Determination 2015/020

Dispute over an amendment to a building consent to use uPVC window and door joinery to a house at 101 Copland Road, Waimumu, Gore

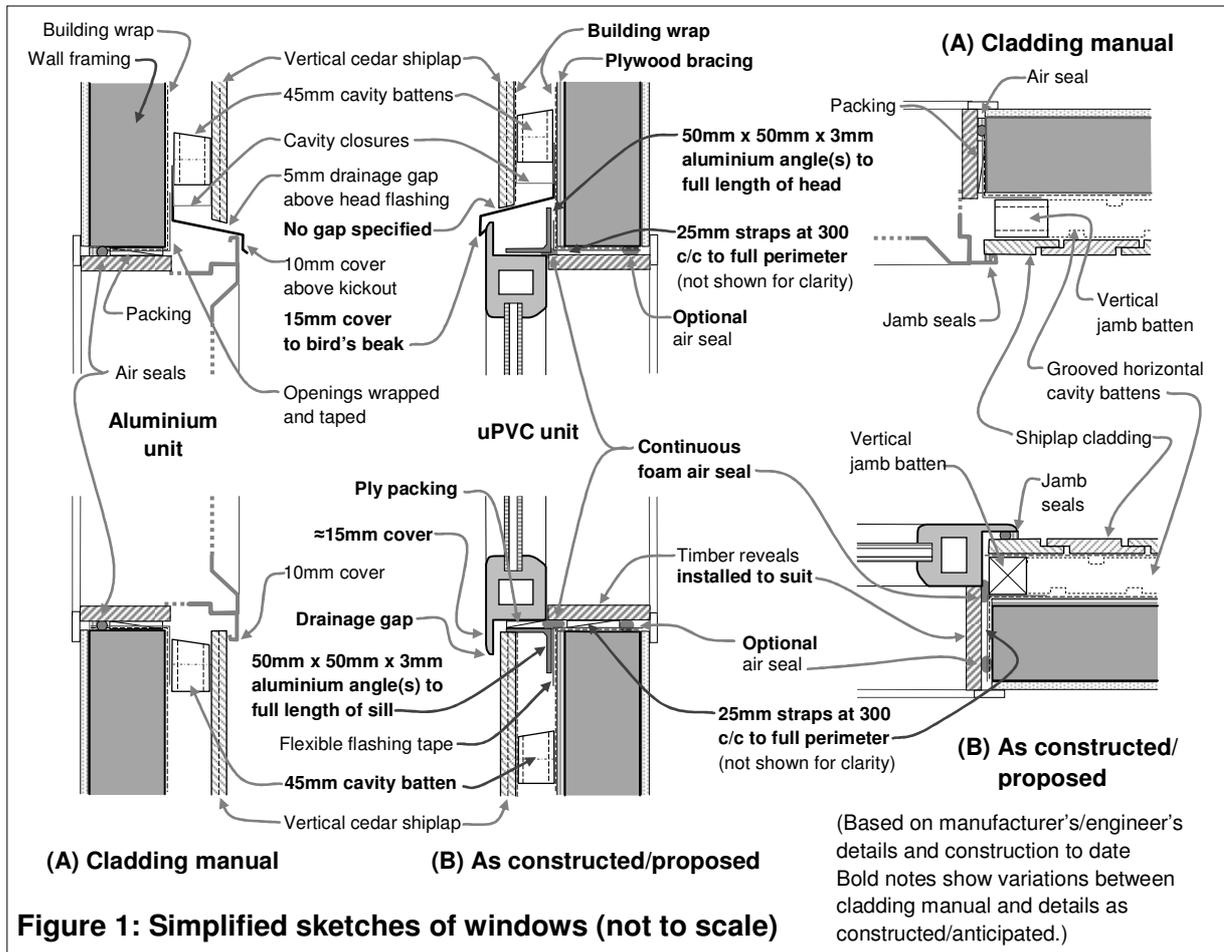
2.4.1 The original consent drawings called for aluminium joinery and the amendment sought to use uPVC windows and doors to be fitted. The installation details, as now proposed by the window supplier, are as shown in outline in Figure 1.

2.4.2 As shown in Figure 1:

- uPVC units are offset from the framing line by up to about 15mm, and photographs and the window supplier's installation details allow for the cedar cladding to underlap jamb flanges to provide a sill drainage gap

- continuous aluminium angles provide sill support fixed into the timber sill plates but not to the window. The engineer's drawings and the supplier's details call for window fixings to be provided by galvanised mild steel '25 x 1 strap braces' to be fixed 'around all four sides at 300crs'

- a continuous aluminium angle to the head provides the backing to the airseal. The angle to the head is not required for structural support and is not shown on the engineer's drawings

- the supplier's details show two continuous expanding foam air seals; with the outer air seal at the unit/wall/reveal junction and the inner noted as an 'optional secondary air seal' located between the reveal and sill plate

- the uPVC units do not include timber reveals which are to be installed by the builder after the installation of the windows.

5.3.3 However, the expert noted that the inner seal, noted as the 'optional secondary air seal' in the window supplier's details, could provide an adequate air seal if satisfactorily installed. This would then make the outer fillet seal redundant and would accord with conventional details for aluminium windows (see Figure 1).

- The amendment details show a continuous air seal at the joinery/framing/reveal junction, with a second optional seal towards the inner trim.
- The joinery units are off-set by up to 15mm beyond the face of the external walls. The 5mm drainage gap to the window sill and jambs are likely to be greater than the 5mm dimension shown in the supplier’s details. A gap greater than 5mm to the sill is likely to result in the entry of wind-blown rain at this junction.

- The amended details do not specify the capillary gap above the head flashing.

6.5.3 Taking into account the above observations, I considered that in order for the proposed joinery installation to be adequate, the following items required attention:

- verification and detailing of the drainage gap between the cladding and the uPVC sill section, and the sealing of the same gap at the jambs
- detailing of the capillary gap above the head flashings.

6.5.4 I acknowledge the revised details now provided by the window supplier in response to the findings of the draft determination (refer paragraph 4.6), and accept that the revised details will satisfy the matters outlined in paragraph 6.5.3 above.
